Access Compliance Report

(Curb Ramps)

Intersection ID: 15489	Main Street: HARVARD_PL	Cross Street: QUEENS_RD	Location: NE
ADA ID: A6853D9A51D1	Ramp Type: Perp	Initial Pass/Fail: Fail	Overall Compliance: No
Severity Score: 50			
Codes/Mitigation Info/Possible Solution		Field Measurements/Component Compliance

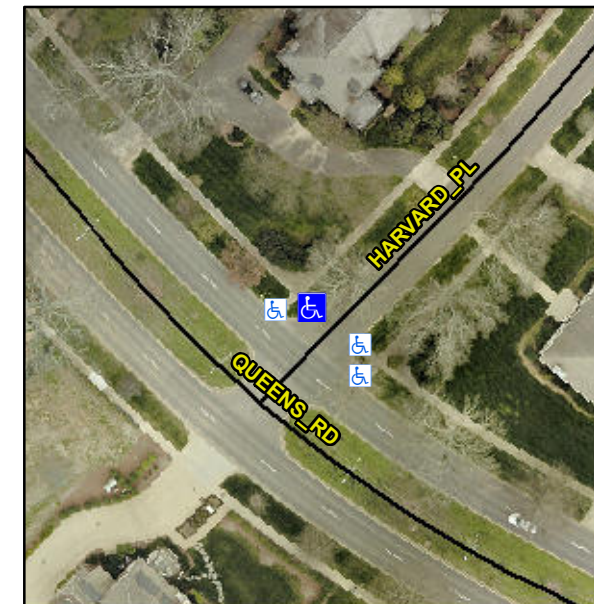
R304.2.2, R304.5.3

Compliance	Description	Data	Compliance	Description	Data
N/A	Ramp Length (in)	91.0	No	Ramp Slope (%)	13.6
Yes	Ramp Width (in)	58.0	No	Ramp XSlope (%)	8.3
N/A	Flare Type LT	N/A	N/A	Flare Type RT	N/A
N/A	Flare Slope LT (%)	N/A	N/A	Flare Slope RT (%)	N/A
N/A	Flare Traversable LT?	N/A	N/A	Flare Traversable RT?	N/A
N/A	Landing Length (in)	N/A	N/A	DWS Provided?	N/A
N/A	Landing Width (in)	N/A	N/A	DWS Contrast?	N/A
N/A	Landing Slope (%)	N/A	N/A	DWS Length (in)	N/A
N/A	Landing X Slope (%)	N/A	N/A	DWS Full Width?	N/A
N/A	Landing Curb? (Y/N)	N/A	N/A	DWS Offset (in)	N/A
N/A	Shared Landing?	N/A			
N/A	Gutter Ponding?	Yes	N/A	Gutter Slope (%)	N/A
N/A	Gutter Lip Ht (in)	N/A	N/A	Gutter X Slope (%)	N/A
N/A	Painted X Walk1?	No	N/A	Painted X Walk2?	N/A
	X Walk 1 Direction	To SE		X Walk 2 Direction	N/A
N/A	X Walk 1 Width (in)	N/A	N/A	X Walk 2 Width (in)	N/A
	X Walk 1 Slope (%)	1.1		X Walk 2 Slope (%)	N/A
	X Walk 1 X Slope (%)	3.0		X Walk 2 X Slope (%)	N/A

Remove & Replace Entire Ramp.
